Braidwood On-site Review and Investigation Report

OSR Number: 90-131 Date: 12-4-90
Subject Review: Offsite Dose Calculation Manual, Braidwood
Chapter 11, Environmental Radiological Monitoring
Table 11-1

Subject: Onsite Review of Braidwood Station ODCM Annex, Rev. 0.B

OFFSITE DOSE CALCULATION MANUAL
BRAIDWOOD STATION

FIGURE 11-3

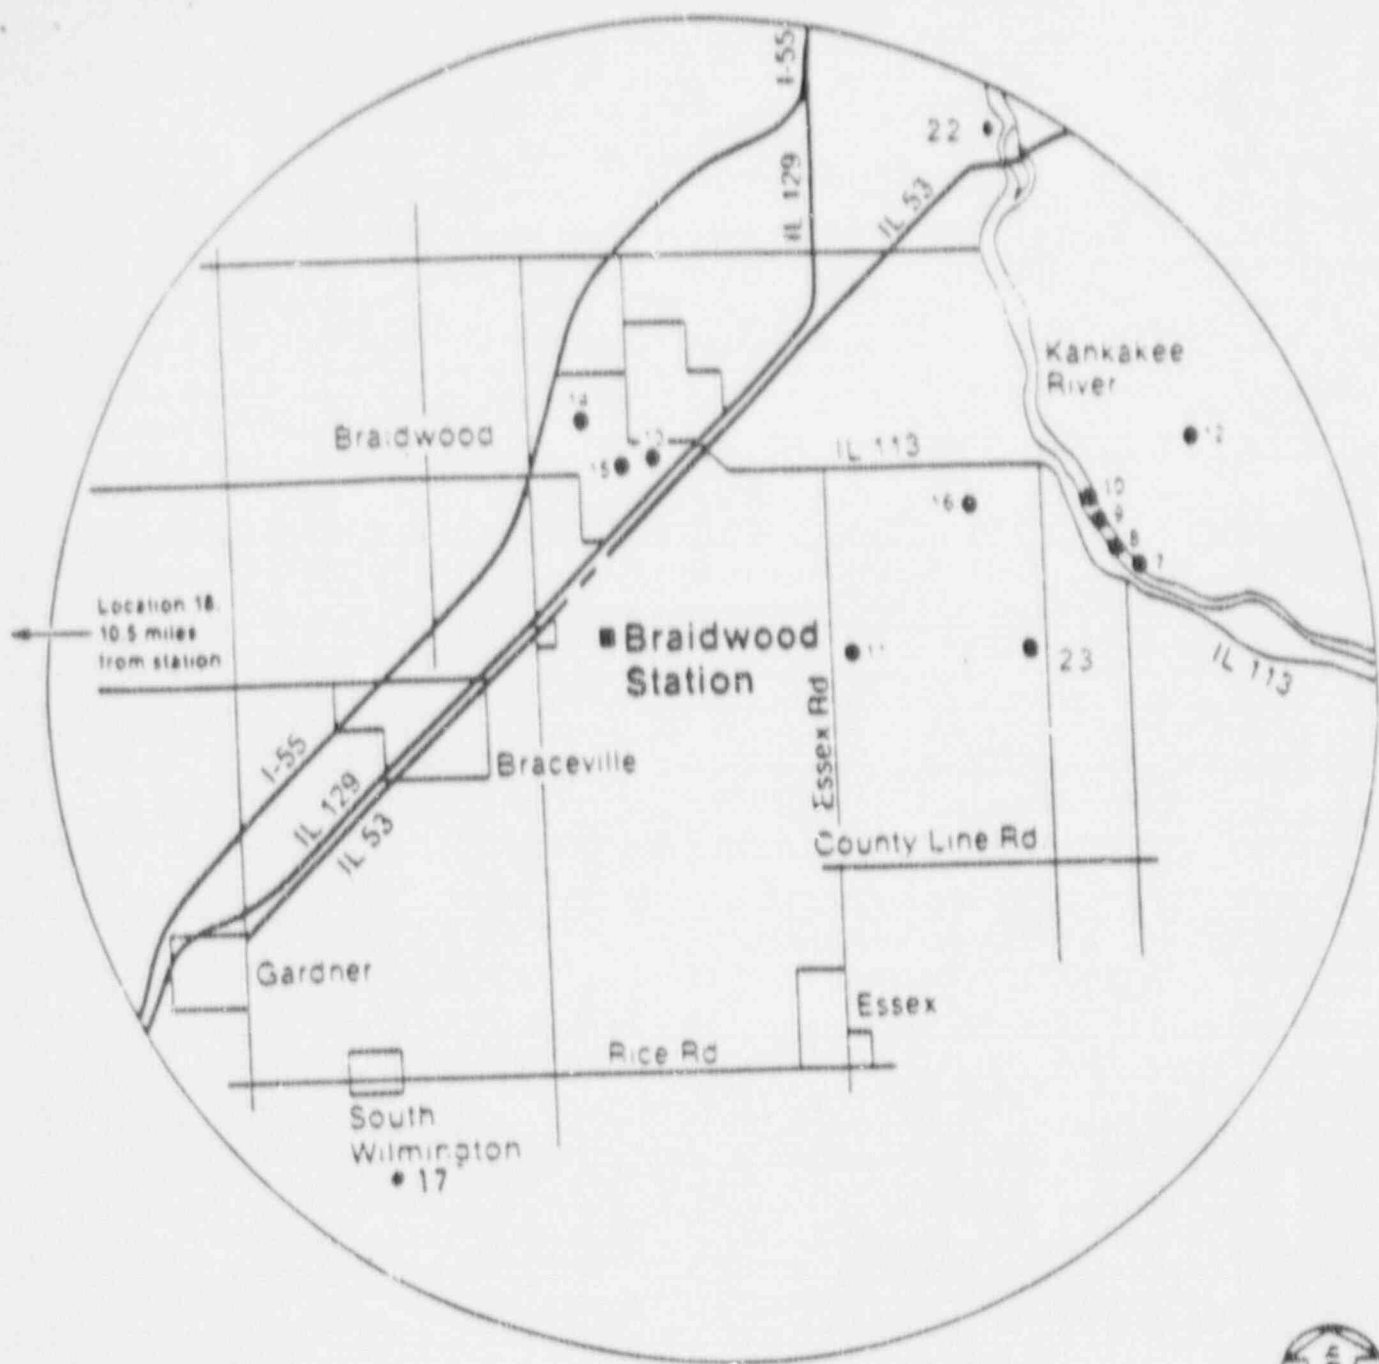
BD-11 Morris Farm, 2.4 mi E was retitled to the Morris/Mack Farm to indicate there is owner/operator relationship. This change is to provide consistent reporting in the ODCM, the Annual Radiological Environmental Operating Report and the REMP Contractor's Monthly Report of analysis results.

BD-17 Trotter's Dairy, 4.8 mi NW (7.7 km Q) was changed to Halpin's Dairy, 5.5 mi SSW (8.8 km K).

BD-23 Klausling's Farm, 4.3 mi E (6.9 km E) was added.

The enclosed revisions have been prepared for approval. Table 11-1 on page 11-7 has been updated to show the Morris/Mack, Halpin's and Klausling's Dairies. Milk samplings for the Radiological Environmental Monitoring Program occur at these locations. Subsequent changes are found in the Index on page 11-1 and to Figure 11-3 on page 11-17.
